System Phase Noise Calculations

Joseph D. DiBona, Senior Engineer Spectrum Microwave

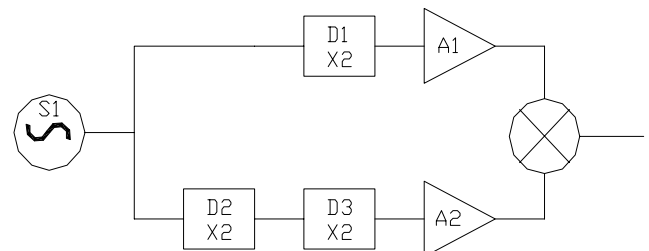
here in this formula the effect of multipliers phase noise has not been considered

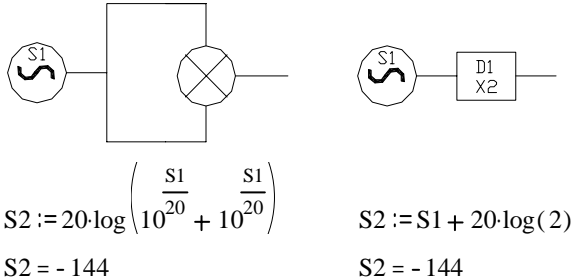
but here we can see some parts that consider the effect of multiplier phase noises
